Work Order ID 69251

Item Name: Crosstube Turning Detail

DRAWING NO. D412-664-243	TITLE CROSSTUBE ASSEMBLY (412 HI AFT)	REV. E	DART AEROSPACE LTD ENGINEERING ORDER		D.E.O. NO. D412-664-243-E-1	SHEET NO. SHEET 1 OF 2	SCALE NTS
DRAWN	CHECKED	MFG. APPR.	APPROVED	DE APPR.			
DATE 11.03.31	DATE 11/03/31	DATE 11.03.31	DATE 11/03/31	DATE 11.03.31

REMOVED ABRASION STRIP IN FAVOR OF A THIN LAYER OF PROSEAL 890.

**D412-664-243
ASSEMBLY DETAIL**

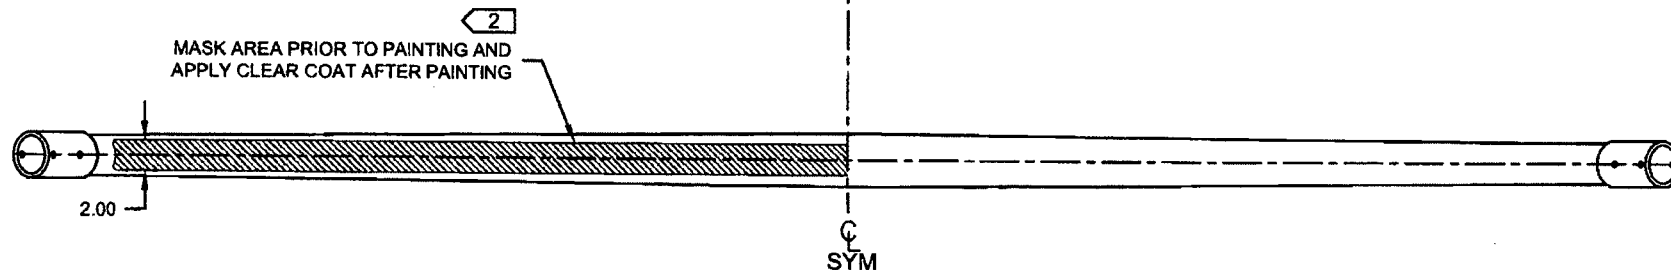
Item	Qty -243	Part Number	Description
6	0	D2856-600-1009	ABRASION STRIP

6	2	D2856-600-1009	ABRASION STRIP
---	---	----------------	----------------

D3189-1 CHAFING SHIELD (1, INSTALLED OVER PROSEAL 890)
MS21920-28 CLAMP, 2X
2 PL

D2856-600-1009 ABRASION STRIP
D3189-1 CHAFING SHIELD (1, INSTALLED OVER ABRASION STRIP)
MS21920-28 CLAMP, 2X
2 PL
